August 3, 1984

HOPE CREEK GENERATING STATION  
DOCKET NO. 50-354  
DRAFT SAFETY EVALUATION REPORT  
OPEN ITEM STATUS

In addition, enclosed for your review and approval (see Attachment 4) are the resolutions to the Draft SER open items, FSAR question responses and structural geotechnical audit item responses, listed in Attachment 3.

FIGURE A-16-17

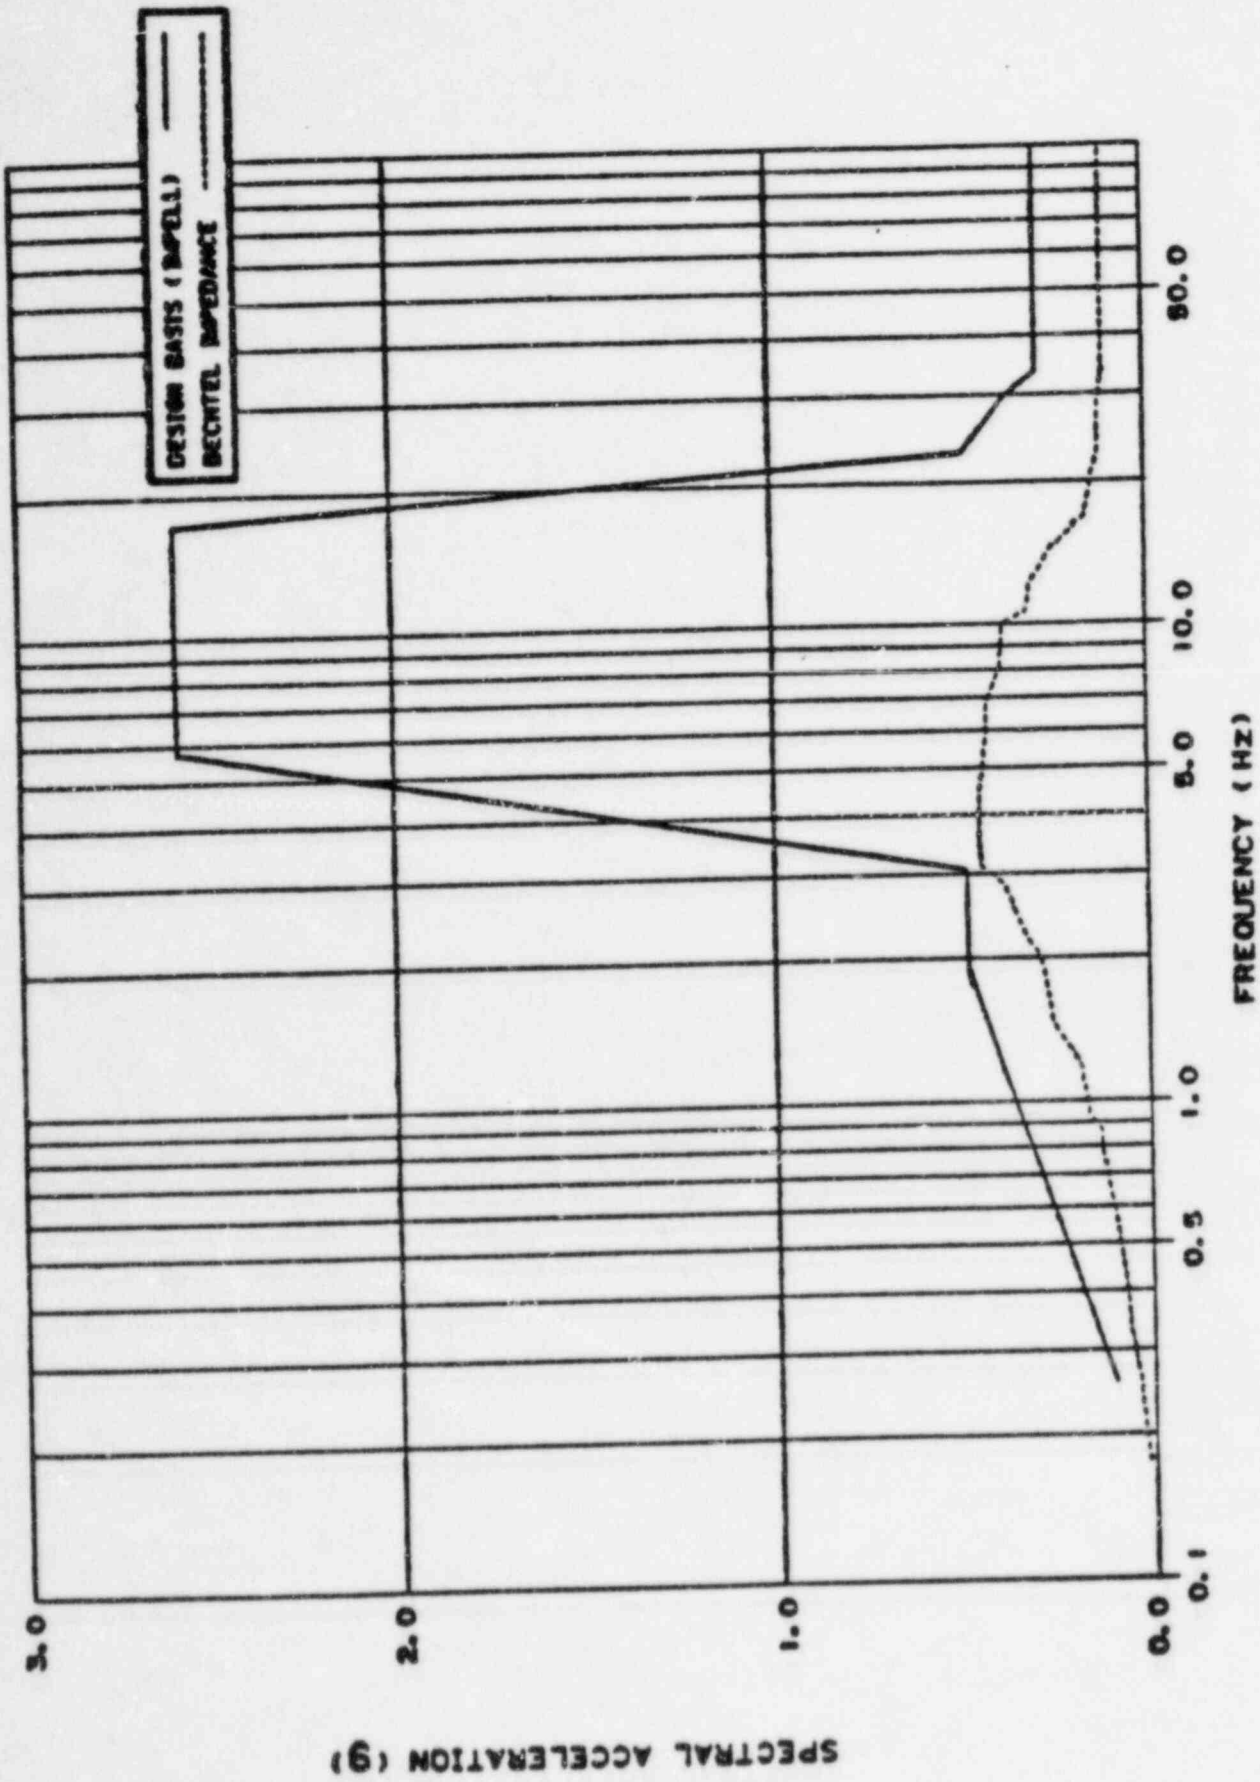
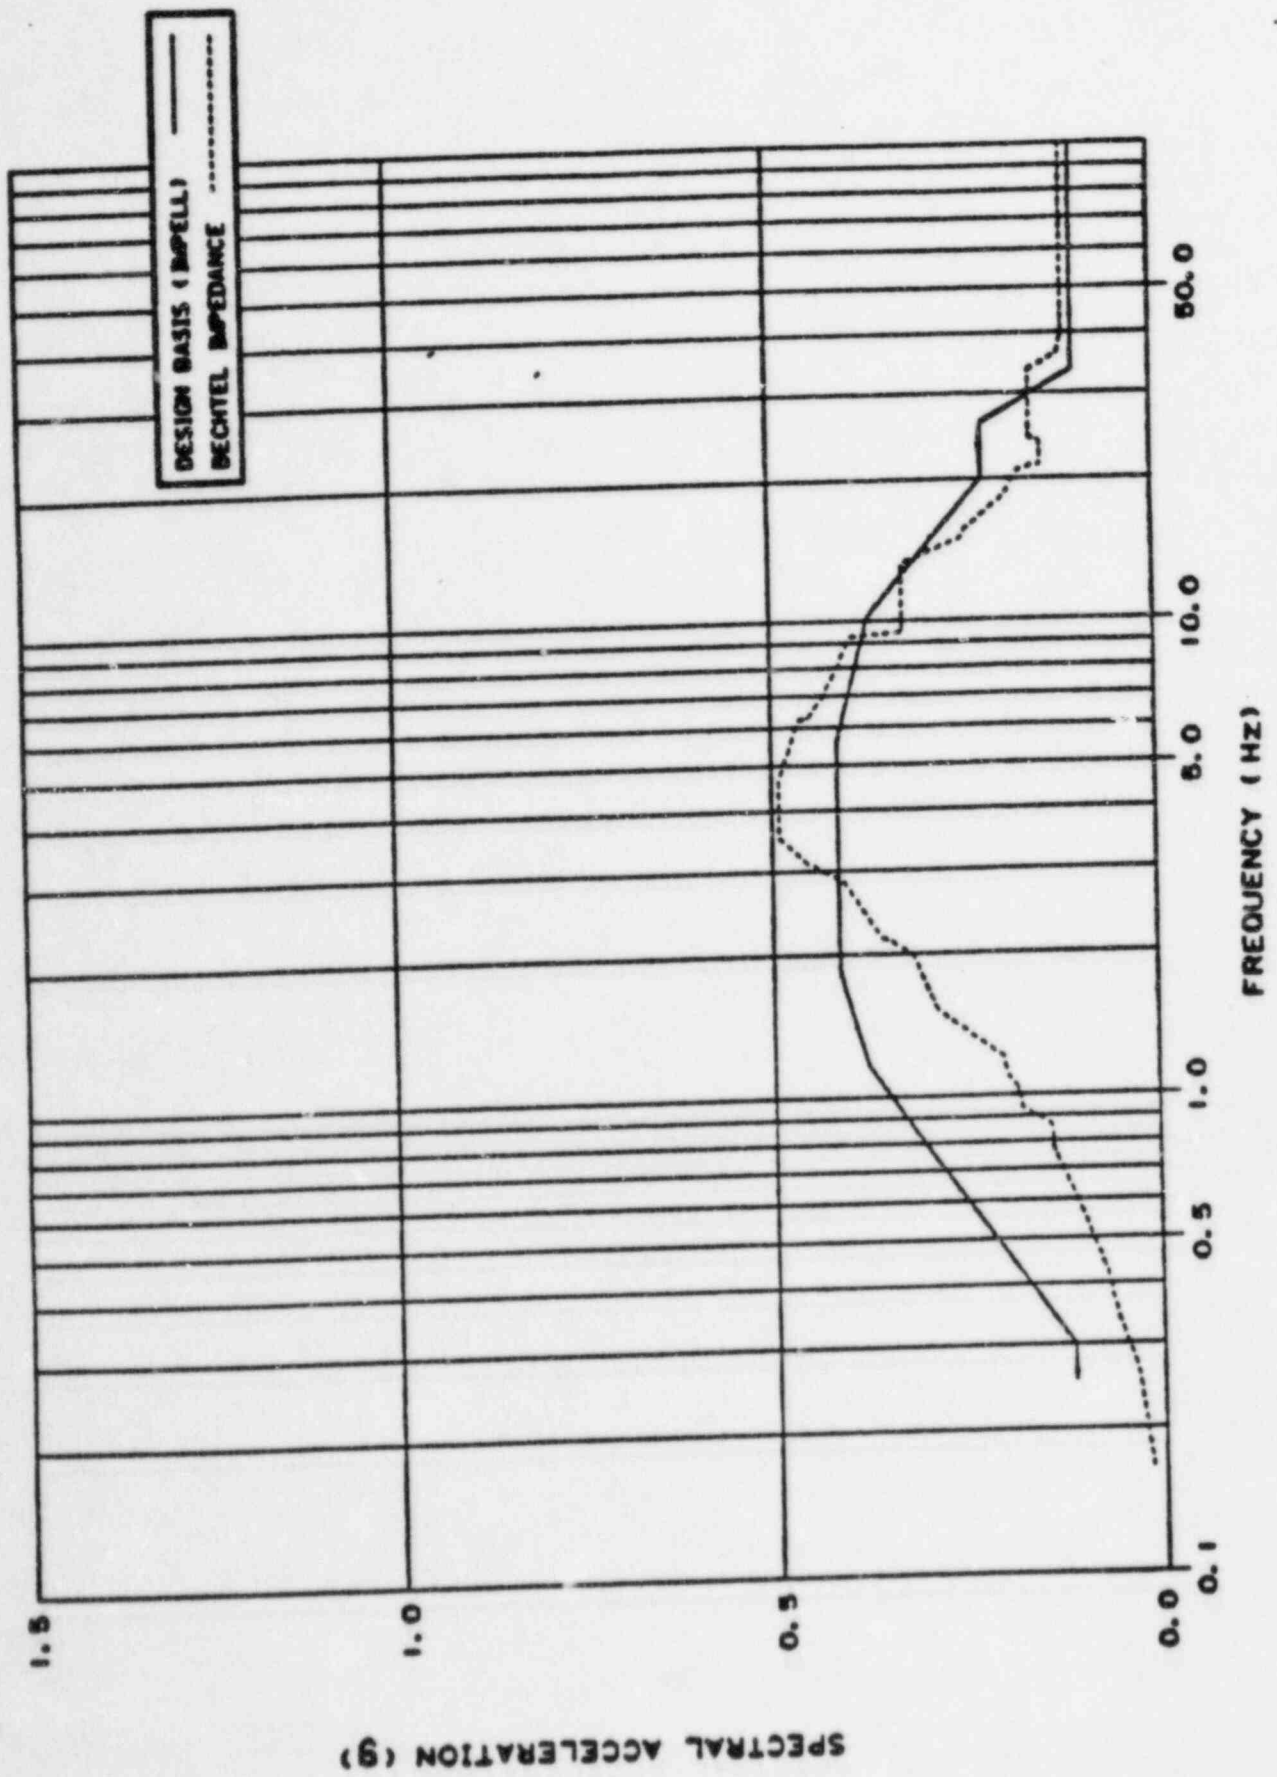
Response

Figures A-16-1 to A-16-18 show the comparison of the 2 percent damping response spectra obtained from the design basis finite element and the impedance approach seismic soil-structure interaction analyses. The impedance approach response spectra generally are enveloped by those obtained from the design basis analyses at elevation 114.0 feet of the SWIS. For other elevations, the impedance approach spectral accelerations exceed the design basis spectral accelerations in some frequency ranges. These ranges vary approximately between 1.5 and 10.0 Hz.

FIGURE 430.145-1

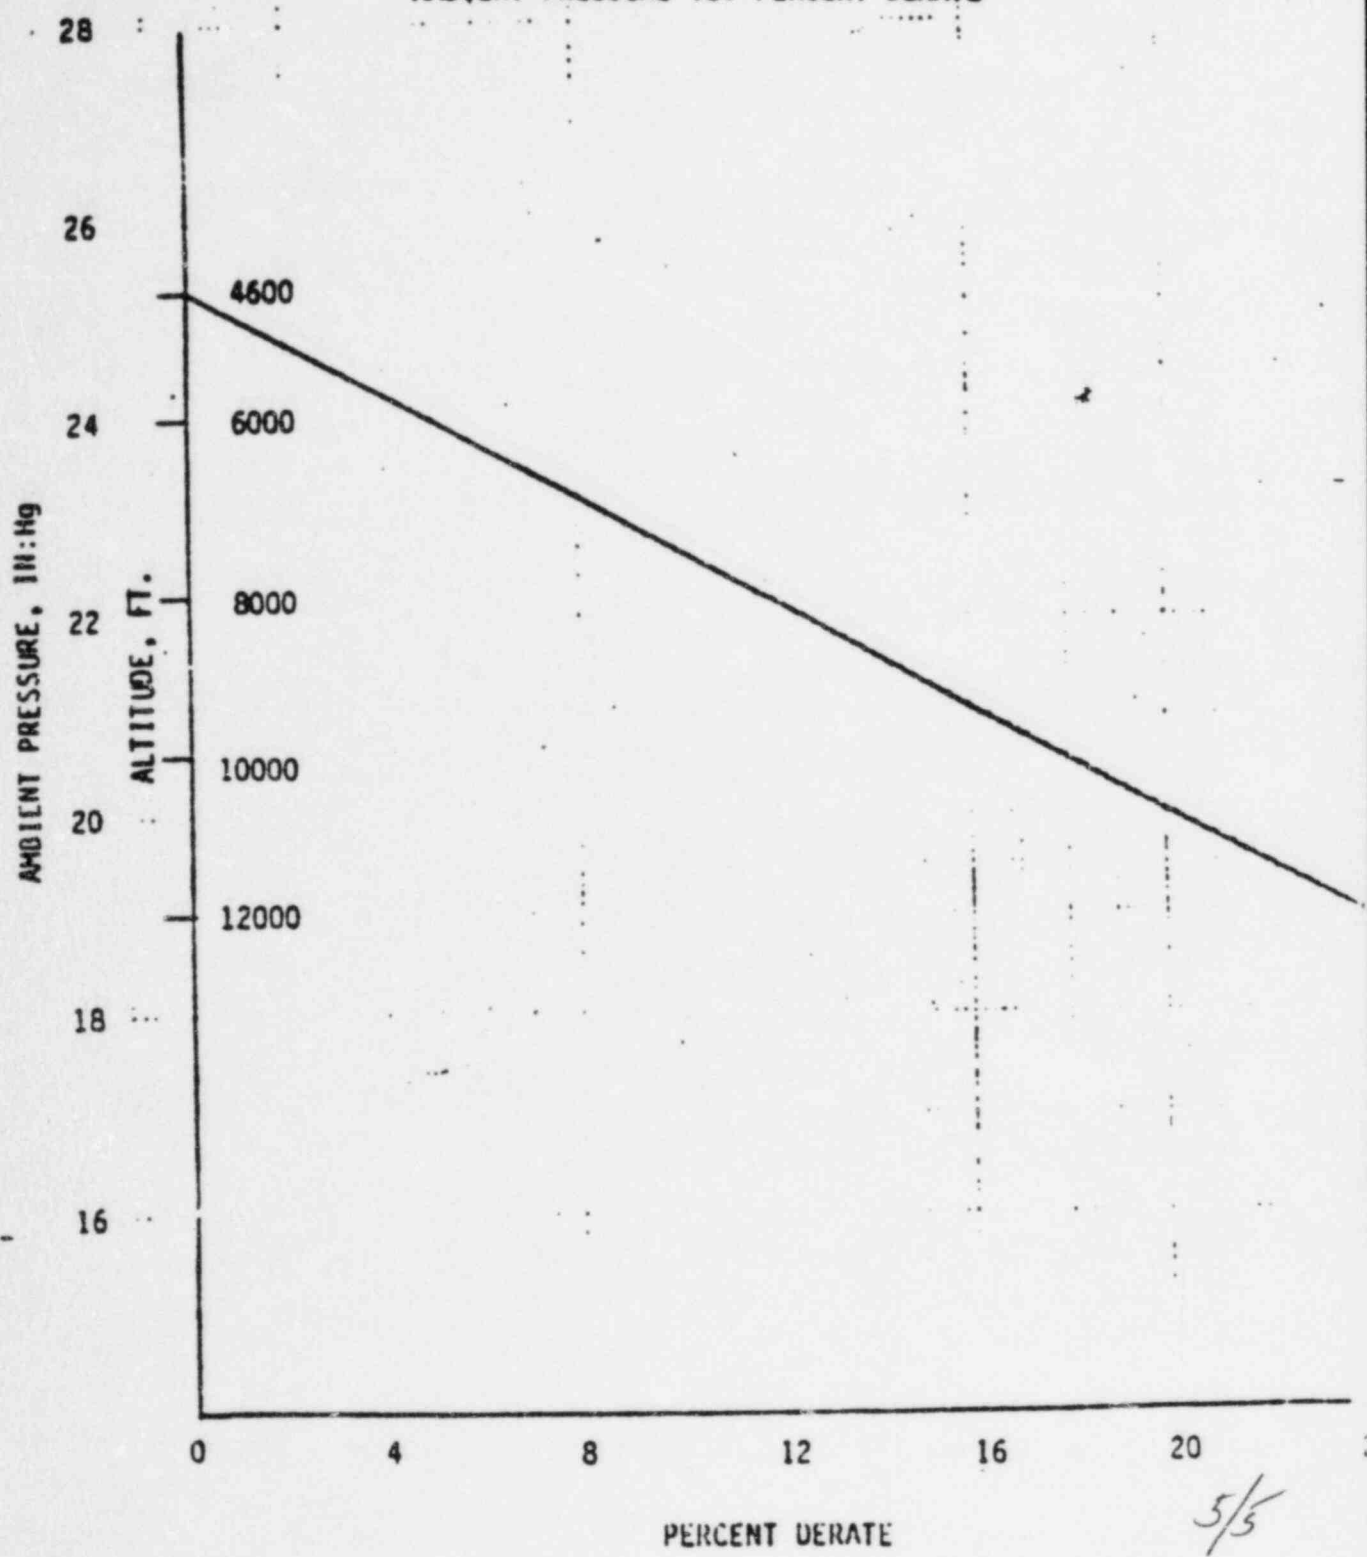
You state in the FSAR that cooling to the diesel engine cooling water systems and the lube oil system is provided by the Safety Auxiliaries Cooling System (SACS). Figures 9.5-23, 9.5-24 and 9.5-27 of the FSAR show the intercooler heat exchanger, the jacket water heat exchanger and the lube oil heat exchanger connected in series with the SACS providing cooling to the intercooler heat exchanger first and the lube oil heat exchanger last. Other plants with the same type of engine design have the lube oil heat exchanger cooled by the diesel engine jacket water system. Rather than cooled by a service water system or have a separate independent connection to the service water cooling system. Justify that your design of having the lube oil heat exchanger in series with the cooling water heat exchangers, will adequately cool and maintain lube oil temperature within manufacturer's specifications during engine operation. (SRP 9.5.7, Part I, II, and III)

- d. A curve of the 12CR.PC2 class engine derating for ambient pressure (altitude) is attached (Figure 430.145-1). It should be noted that this curve is applicable on the long term basis - altitude derating - and is not applicable to short term phenomena such as tornadoes, hurricanes, tropical storms, or other weather depresssions.
- e. The diesel engine manufacturer confirms that as long as the unit is adequately maintained (air intake filters kept cleaned, etc), there are no other conditions adverse to the engine.
